## ArevaEPRDCPEm Resource

**From:** Pederson Ronda M (AREVA NP INC) [Ronda.Pederson@areva.com]  
**Sent:** Friday, February 13, 2009 7:18 PM  
**To:** Getachew Tesfaye  
**Cc:** BENNETT Kathy A (OFR) (AREVA NP INC); DELANO Karen V (AREVA NP INC); VAN NOY Mark (EXT); HARRIS Carolyn A (AREVA NP INC)  
**Subject:** Response to U.S. EPR Design Certification Application RAI No. 155, FSAR Ch. 3  
**Attachments:** RAI 155 Response US EPR DC.pdf

**Subject:** Response to U.S. EPR Design Certification Application RAI No. 155, FSAR Ch.  
3  
**Sent Date:** 2/13/2009 7:18:13 PM  
**Received Date:** 2/13/2009 7:18:20 PM  
**From:** Pederson Ronda M (AREVA NP INC)

**QUESTIONS for Structural Engineering Branch 2 (ESBWR/ABWR Projects) (SEB2)**

**Figure 03.08.01-14 — Tendon Temperature Gradient**

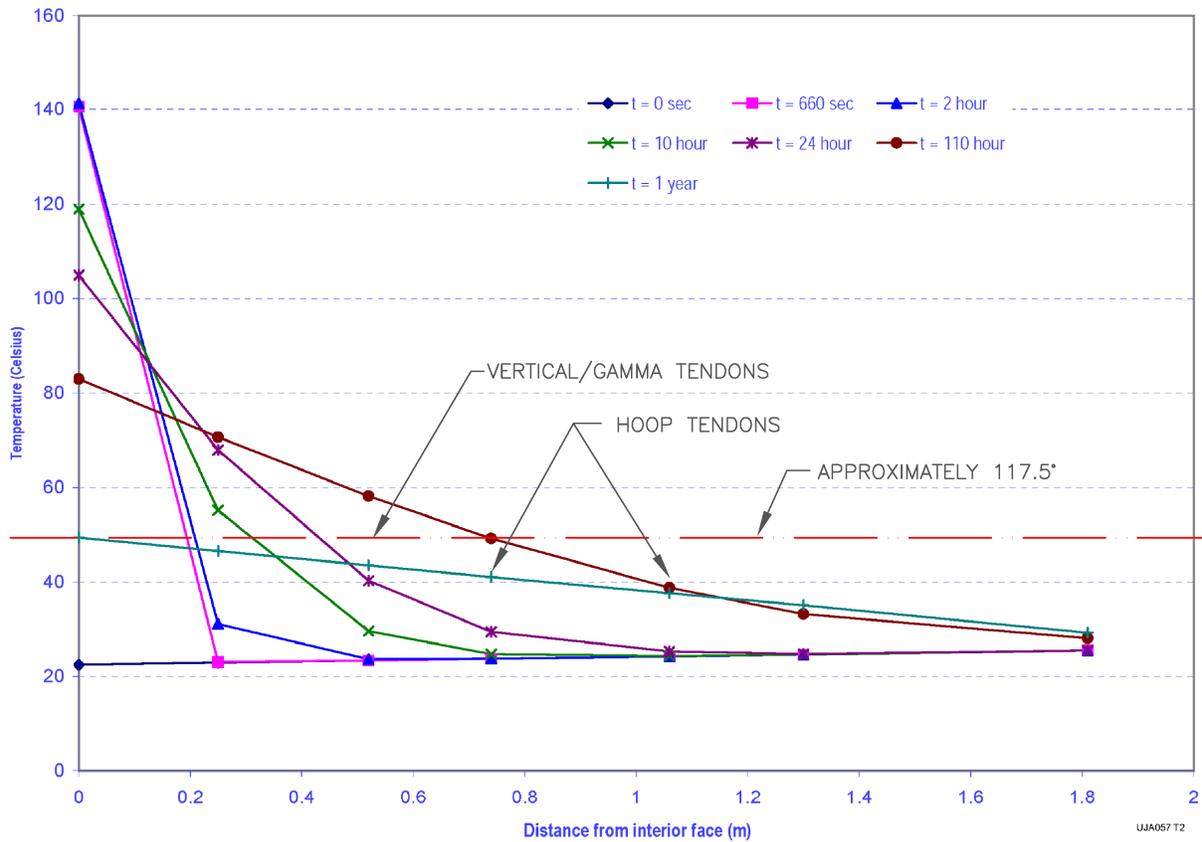
1. Section 3.8.1.4.4 of the FSAR states that for purposes of this calculation an annulus temperature of 79 F was assumed. FSAR Section 3.8.1.3.1 states that the RB annulus internal ambient temperature can vary from 113F maximum to 45F minimum. Provide the basis for not assuming a lower annulus temperature in determining the temperature gradient through the wall and describe the impact on the wall analysis and design.
2. For the wall temperature gradient described in FSAR Section 3.8.1.4.4, describe the effect of temperature on tendon prestress and whether this effect was considered in the analysis and design of the containment wall. Also describe how the variations in the temperature of the RB annulus were considered in this analysis and if they were not considered provide justification for not doing so.

1. To determine the temperature gradient of the reactor containment building (RCB) wall the average annulus temperature of 79°F was used on the exterior surface. The time dependent temperature profile due to a loss of coolant accident (LOCA), provided in U.S. EPR FSAR Tier 2, Figure 3.8-20, was used as the temperature variation on the interior surface of the RCB wall. Using these temperature loads, a thermal transient analysis was performed using ANSYS to determine the internal forces in the containment wall.

The analysis did not consider lower annulus temperature because it is not credible that both the accidental temperature in the RCB (309.2°F) and the minimum annulus temperature (45°F) will occur at the same time. Furthermore, it is anticipated that the temperature variation between the average and minimum temperatures of the annulus (79°F - 45°F = 34°F) will have minimal effect on stresses in the wall. RAI 155, Question 3.8.1-16 response will show that an axisymmetric model is generated to investigate effects of varying material properties. This model will also investigate the effect of annulus temperature variation relative to the 79°F value used to date.

2. Tendon average temperature affects pre-stress losses due to steel relaxation. An average tendon temperature of 117.5°F was used in the calculation of pre-stress losses. This was determined as follows:
  - U.S. EPR FSAR Tier 2, Section 3.8.1.3.1 shows the maximum ambient temperatures for normal plant operation of the annulus (outside face of the RCB wall) and the two rooms of the containment (inside face of the RCB wall).
  - Maximum annulus temperature (113°F) was used for the RCB wall outer face temperature. This is conservative in calculating pre-stress losses because steel has higher relaxation at higher temperatures.
  - Maximum equipment area temperature is 131°F and the service area is 86°F. Consistent with containment HVAC system heat load calculations, an average temperature of 122°F was used for the RCB wall inside face.

Once the average temperature of the tendons was determined, results of several recent 1000-hour steel relaxation tests for ASTM A416 material were reviewed and a representative  $\rho_{1000}$  (1000-hour steel relaxation percentage) value of 1.7% was selected. These tests were performed at a temperature of 68°F, as prescribed by ASTM A416. No recent test data was found for ASTM A416 material at temperatures other than 68°F. Therefore, to provide additional margin for temperatures above 68°F, the selected value for  $\rho_{1000}$  was increased by 50%. The 1000-hour steel relaxation percentage used for the determination of steel relaxation was  $(1.7\%)(1.5) = 2.55\%$ .

Consideration of the LOCA temperature gradient was not directly incorporated into the calculation for steel relaxation losses. Figure 03.08.01-14 (also U.S. EPR FSAR Tier 2 Figure 3.8-22—Temperature Gradient Through Cylinder Wall) shows temperature gradients of the cylindrical wall at:

All time points except for the t = 1 year time point are relatively short term, and therefore have little effect on long term phenomena such as tendon relaxation. Effective tendon temperature as pertinent to stress relaxation is estimated using the average of the t = 110 hour and t = 1 year time points. As shown in Figure 03.08.01-14, vertical/gamma tendon temperature during a LOCA is approximately 117.5°F. Maximum hoop temperature is approximately 115°F. Therefore, the tendon temperature used for determining pre-stress losses (117.5°F) exceeds LOCA tendon temperature and is conservative.

Annulus temperature variations were not considered in determining pre-stress loss due to steel relaxation. Steel relaxation varies directly with temperature. Therefore, use of maximum annulus temperature (113°F) results in a higher average tendon temperature and a higher pre-stress loss due to steel relaxation (i.e., the calculation is conservative).
